This is to certify that Mesden Llc /Granite Construction
has permission to Build 5 unit condominium
AT 20 Brackett St 058 F013001

City of Portland, Maine - Building or Use Permit Application

To: Glenn L. Morin Jr.
From: Mike Nugent/Manager of Inspection Services
Date: 08/14/2003
Re: 20-24 Brackett St.

PARTIAL REVIEW COMMENTS>>>>>>>>>>>>>>>>>>>>>>>>>

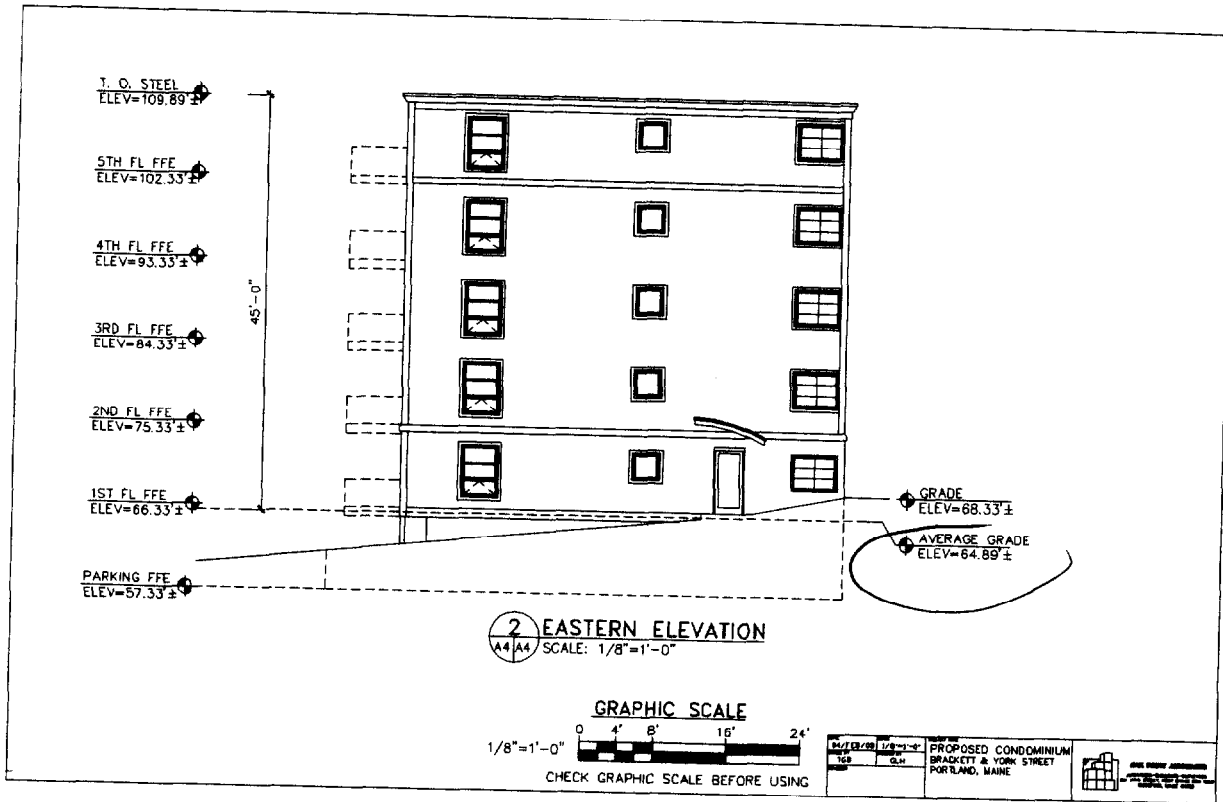
109.89 Top of Steel
 64.89 - Average Grade

Revised height as shown
 See plans submitted with permit
 Revise these figures

Top of steel
 108.65
 63.65

45.00 high
 OK

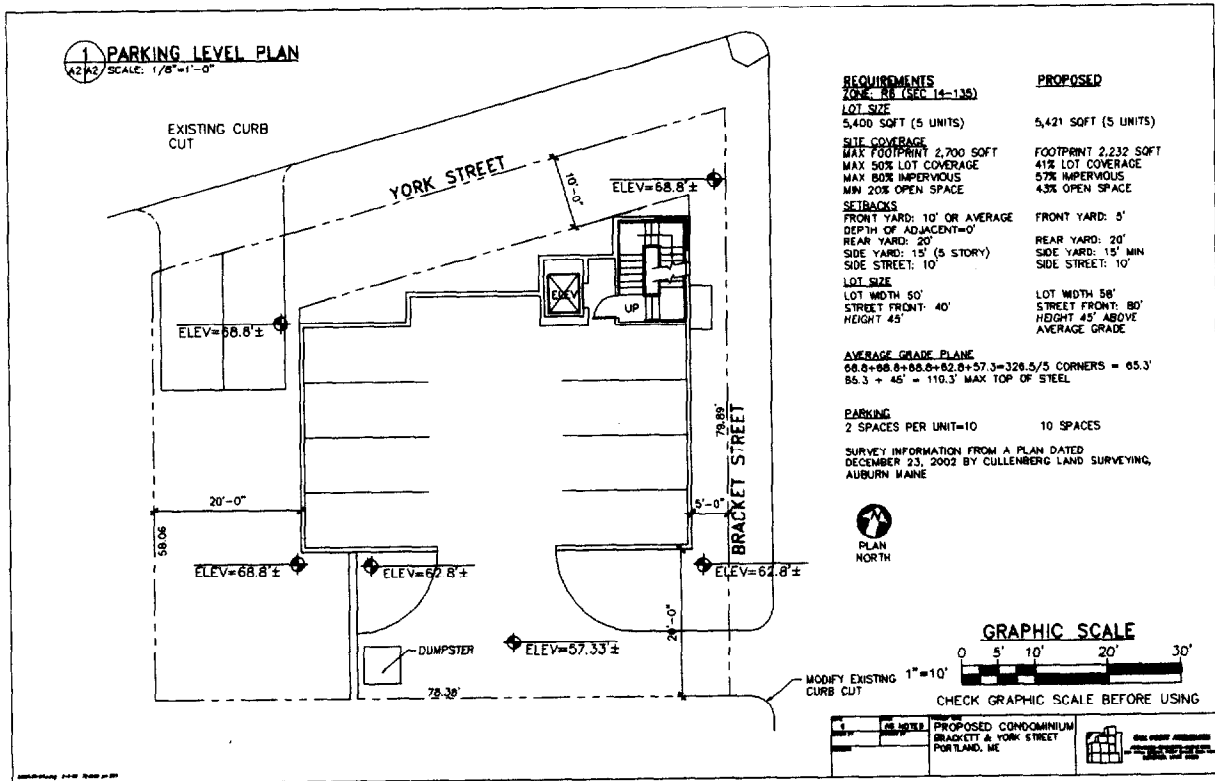
I have recently received, by e-mail, new sketches of this project showing revisions to building height and also showing the projection of the southerly decks on the plot plan. Scalable plans will be dropped off this morning.

REQUIREMENTS	PROPOSED
ZONE: RB (SEC 14-13B)	
LOT SIZE 5,400 SQFT (5 UNITS)	5,421 SQFT (5 UNITS)
SITE COVERAGE MAX FOOTPRINT 2,700 SQFT MAX 50% LOT COVERAGE MAX 80% IMPERVIOUS MIN 20% OPEN SPACE	FOOTPRINT 2,232 SQFT 41% LOT COVERAGE 57% IMPERVIOUS 43% OPEN SPACE
SETBACKS FRONT YARD: 10' OR AVERAGE DEPTH OF ADJACENT=0' REAR YARD: 20' SIDE YARD: 15' (8 STORY) SIDE STREET: 10'	FRONT YARD: 5' REAR YARD: 20' SIDE YARD: 15' MIN SIDE STREET: 10'
LOT SIZE LOT WIDTH 50' STREET FRONT: 40' HEIGHT 45'	LOT WIDTH 58' STREET FRONT: 80' HEIGHT 45' ABOVE AVERAGE GRADE

AVERAGE GRADE PLANE
 $68.8 + 68.8 + 68.8 + 62.8 + 57.3 = 328.5 / 5 \text{ CORNERS} = 65.7$
 $65.3 + 45 = 110.3 \text{ MAX TOP OF STEEL}$
